# Staff Summary Report

Development Review Commission Date: 06/14/2011

**SUBJECT:** Hold a public hearing for a Development Plan Review and Use Permit for FIRESTONE COMPLETE AUTO CARE located at 930 East Baseline Road.

**DOCUMENT NAME:** DRCr\_FirestoneLCVPh1\_061411.doc **PLANNED DEVELOPMENT (0406)**

DRB  
CONCEPTUAL  
SITE PLAN

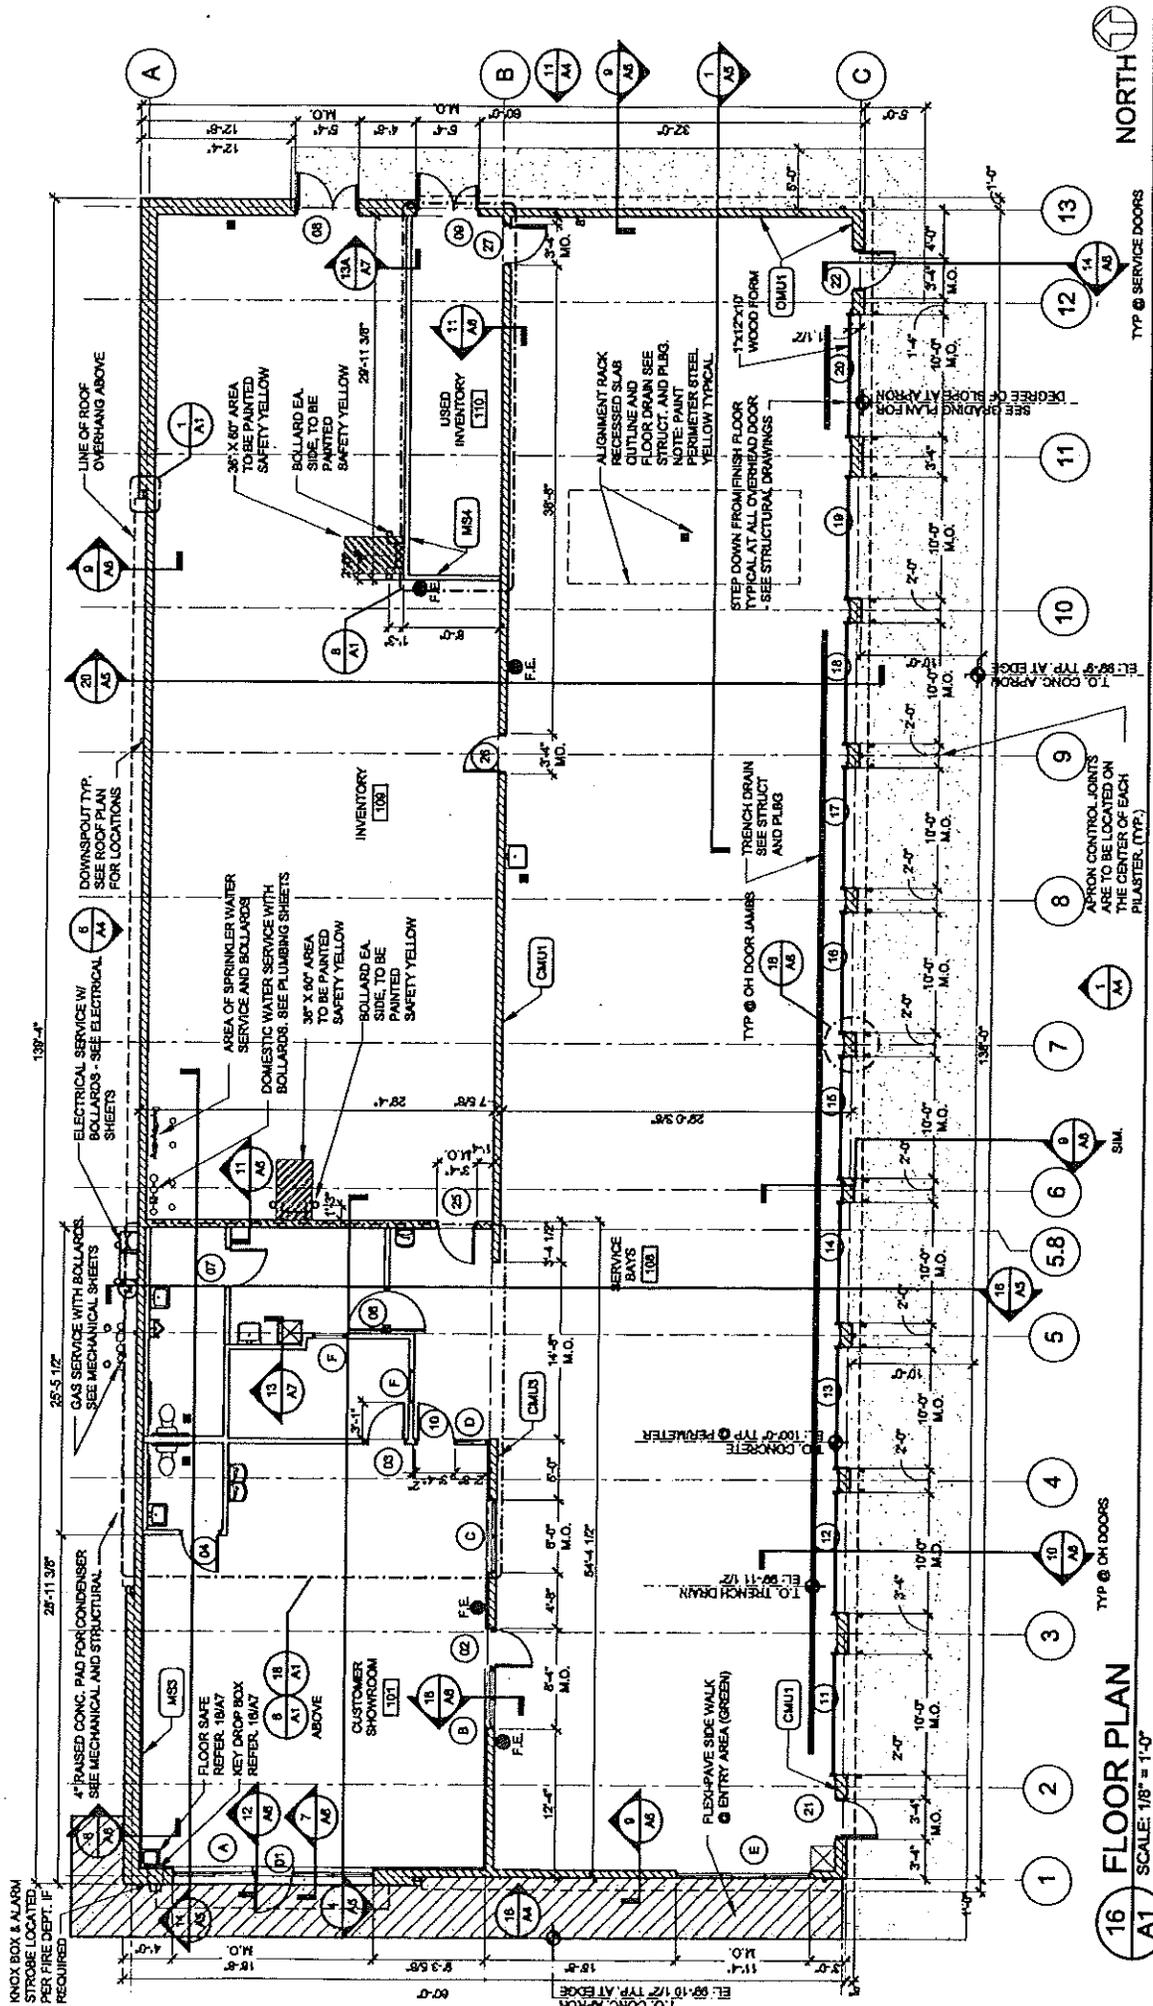
10. Modify refuse enclosure so south wall is removed and west wall of enclosure connects directly to north wall of building. This will remove a narrow exterior alcove that may be used as a hiding place. Provide detail of refuse enclosure and service courtyard screen wall that matches the architectural expression of the building. Finish "inside" of the wall facing courtyard and enclosure.

11. Provide one (1) bicycle parking space near Pad 'A' building entrance.
12. Move Pad 'A' building and service courtyard screen wall minimum 3'-0" to the south to create a minimum 3'-0" wide planting strip between the Minton Drive walkway and the screen wall.

13. Provide 3'-0" high masonry screen wall at parking along Jentilly Lane as indicated. Provide a minimum 6'-0" high masonry courtyard screen wall and refuse enclosure wall along Minton Drive and Jentilly Lane to the north and northwest of Pad 'A' except reduce the wall height from 6'-0" to 3'-0" at the easternmost 20'-0" length, adjacent to the driveway. Do not locate screen walls within the sight visibility triangles of adjacent driveways or at the intersection of Jentilly and Minton.

14. At Pad 'A' driveways to private streets Jentilly Lane and Minton Drive, provide driveways in conformance with Tempe Standard Detail T-320. Provide upgraded paving consisting of scored concrete on site behind each driveway sidewalk bypass. At the entire paved vehicle courtyard on the north of the Pad 'A' building, provide scored concrete paving. Extend concrete paving at driveway aprons elsewhere to the extent of on-site drive aisle curbs that are parallel with the adjacent private street.

**1 (EAST) ELEVATION**  
 A4 SCALE: 1/8" = 1'-0"

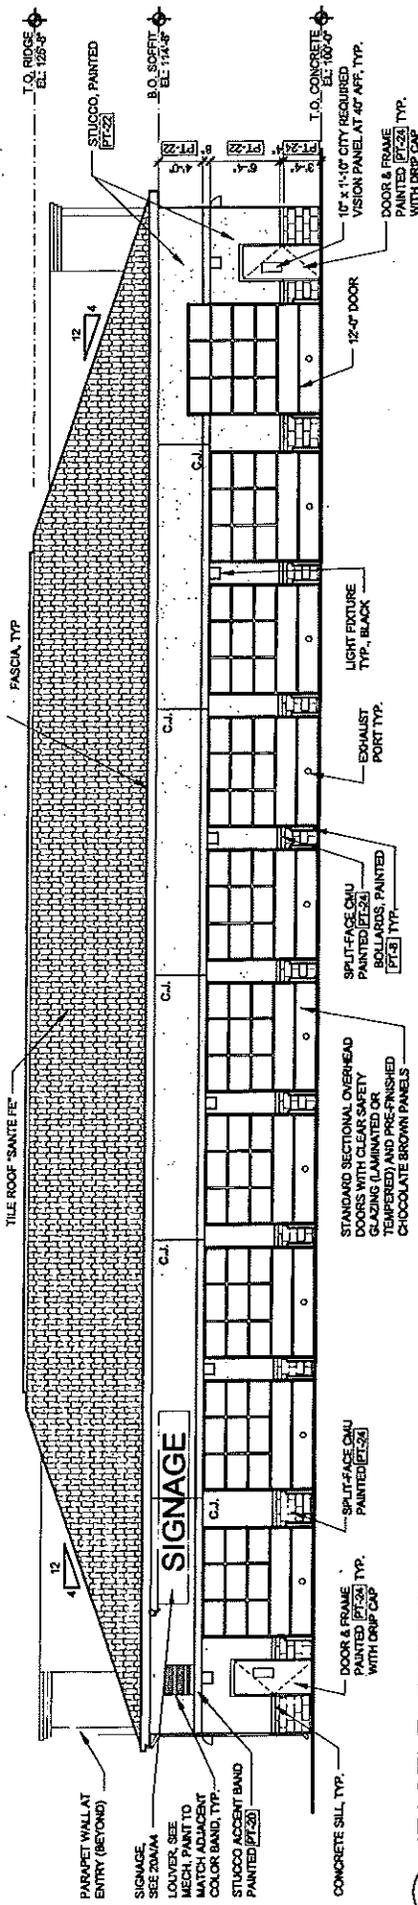
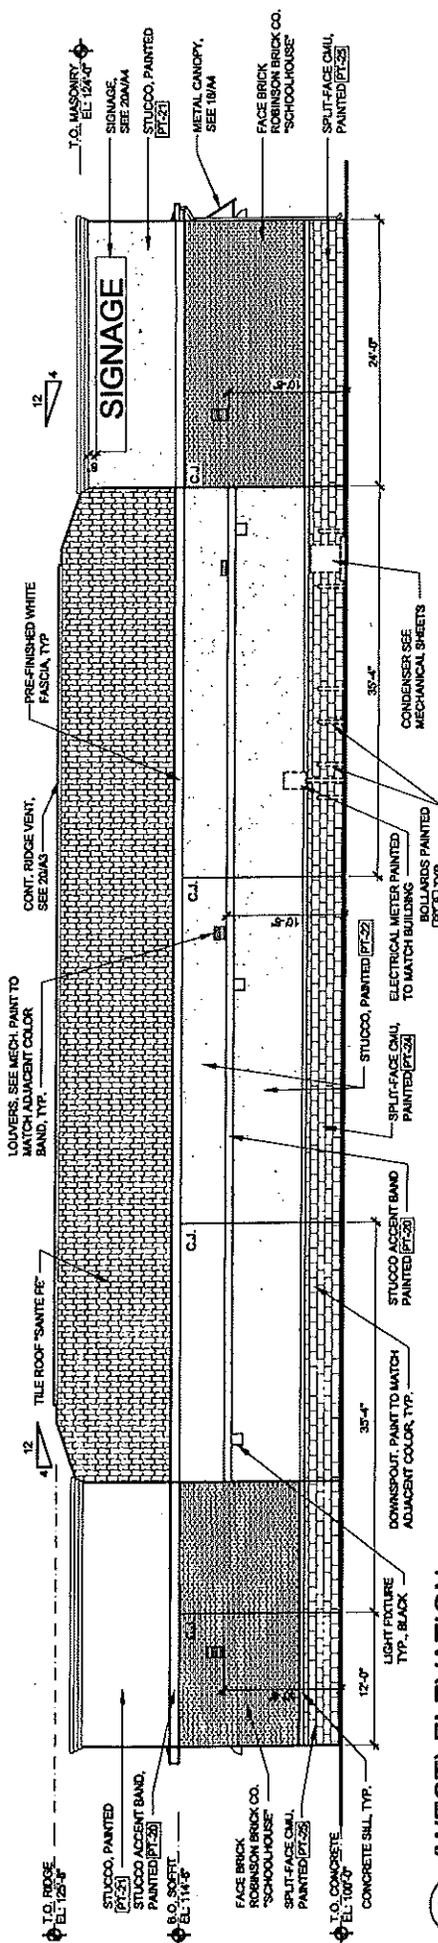
17. Northwest and southwest corners of the building provide partial parapet towers which appear to enclose roof top mechanical equipment wells. Complete these parapets adjacent to sloped roof to provide a continuous four-sided screen that is at least the height of the equipment that is enclosed. Demonstrate the two screened areas with roof plan and sections as needed.

18. Provide a canvas black awning and frame above the storefront entrance similar to that proposed for Shops 'A' of Phase One.
19. Specific paint colors, red brick veneer, red barrel tile, black canvas awning and dark bronze anodized aluminum that are exhibited on the Lake Country Village materials sample board, dated May, 2, 2011 are approved. Maintain main colors and materials with a light reflectance value of 75 percent or less. Submit additions or modifications for review during building plan check process. Major modifications require separate Development Plan Review by the Development Review Commission.

20. Provide secure roof access to mechanical roof wells from the interior of the building. Do not expose roof access to public view.
21. Gutter concealed within formed plaster "cornice" at sloping roof, roof drain downspouts concealed within the exterior brick veneer on south, north and west elevations, and exposed metal downspouts mounted on the east elevation are all acceptable.

**Lake Country Village**  
NWC Lakeshore Drive & Baseline Road  
Tempe, Arizona

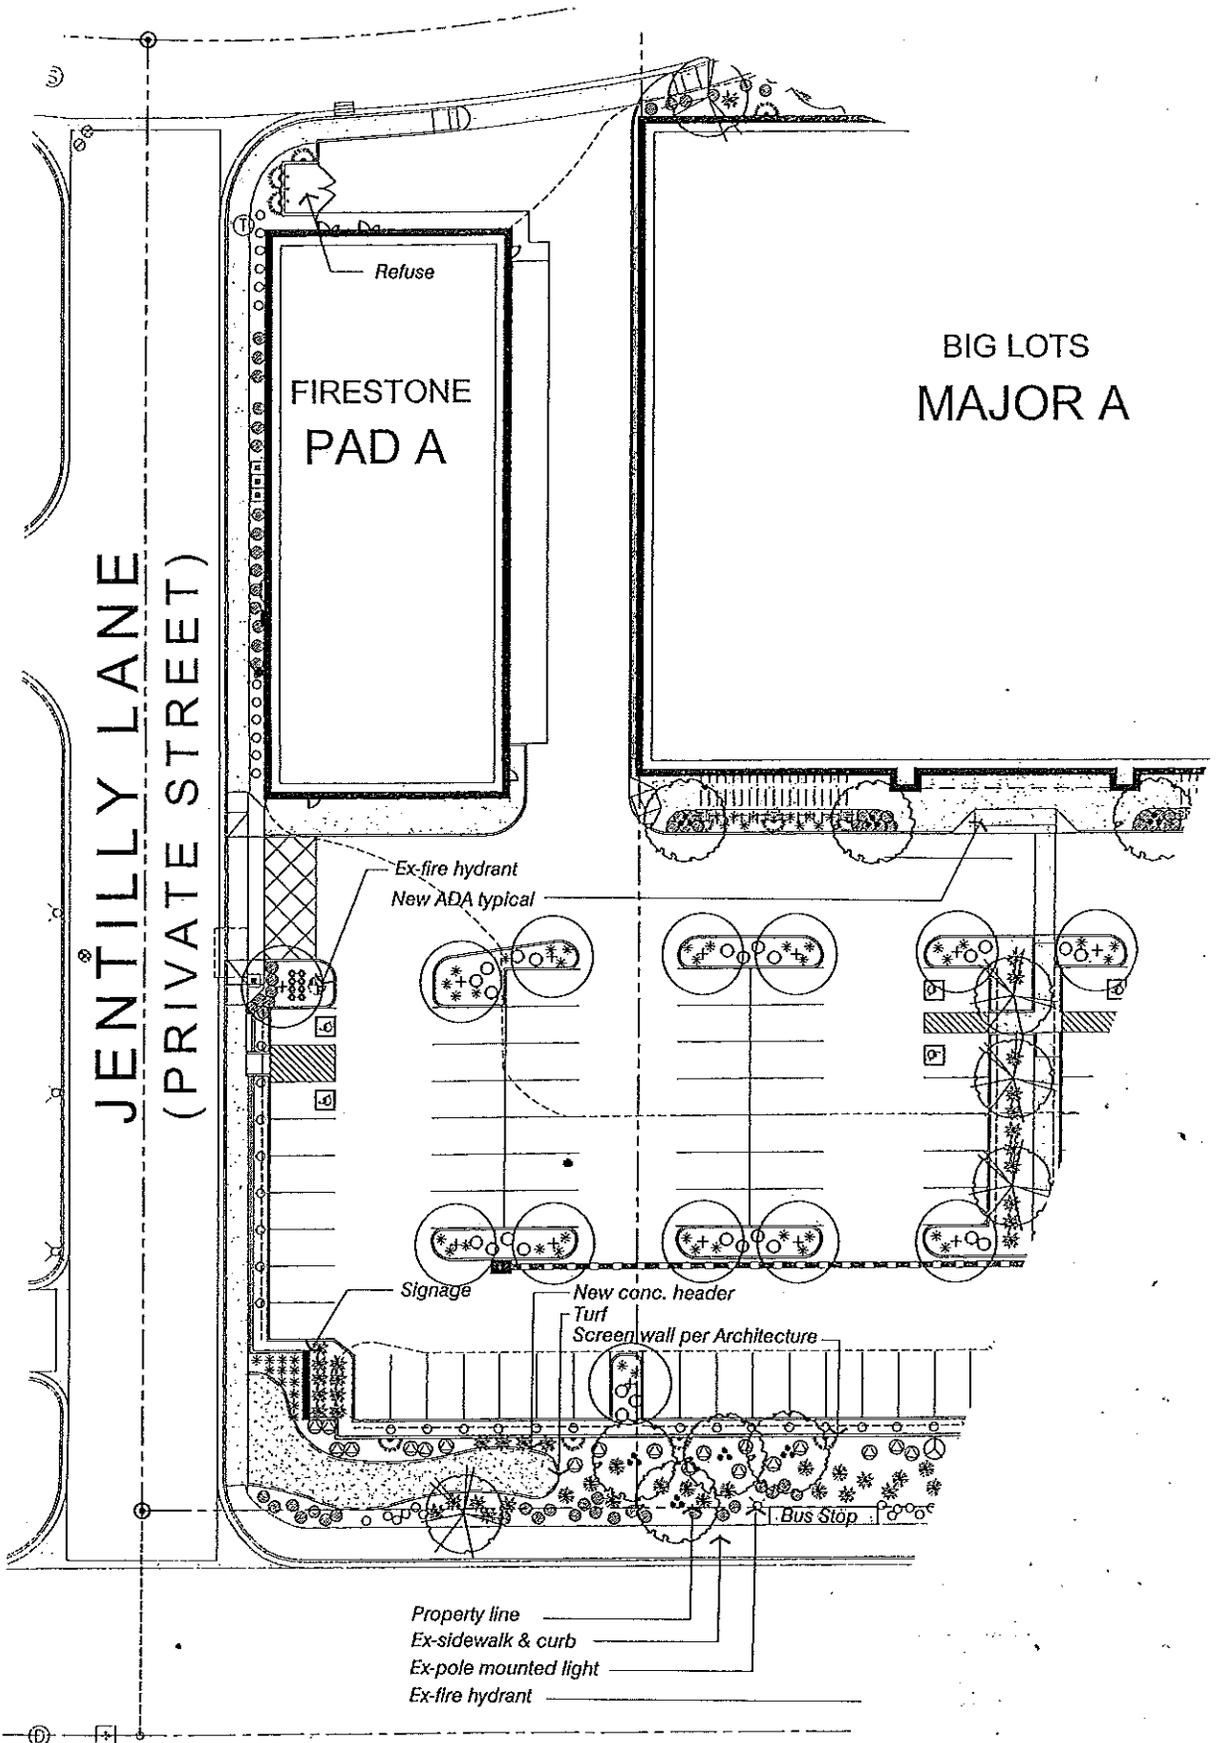
25. Provide additional trees along private streets Jentilly and Minton. Provide two trees on west of site between parking and Jentilly Lane walkway. Position these trees to align with parking space stripes. Provide three trees west of Pad 'A' building on Jentilly Lane. Provide one tree on Minton Drive north of the Pad 'A' service courtyard screen wall.

26. Irrigation notes:
  - a. Provide automatic irrigation system that is part of the entire Lake Country Village system or is independent and is exclusive to Pad 'A' and the adjacent Baseline Road public right of way. Provide details of water distribution system.

- b. Provide system of buried rigid (polyvinylchloride), not flexible (polyethylene) pipe. Provide schedule 40 PVC mainline. Provide minimum class 200 PVC feeder line except provide minimum class 315 PVC feeder line for ½" diameter size.

28. Top dress planting areas with a rock or decomposed granite application. Provide groundcover top dressing of 2" uniform thickness. Provide pre-emergence weed control application. Do not underlay rock or decomposed granite application with plastic. If Pad 'A' is not concurrently developed with Major 'A' and Shops 'A', provide a decomposed granite groundcover for the undeveloped areas of Pad 'A'.
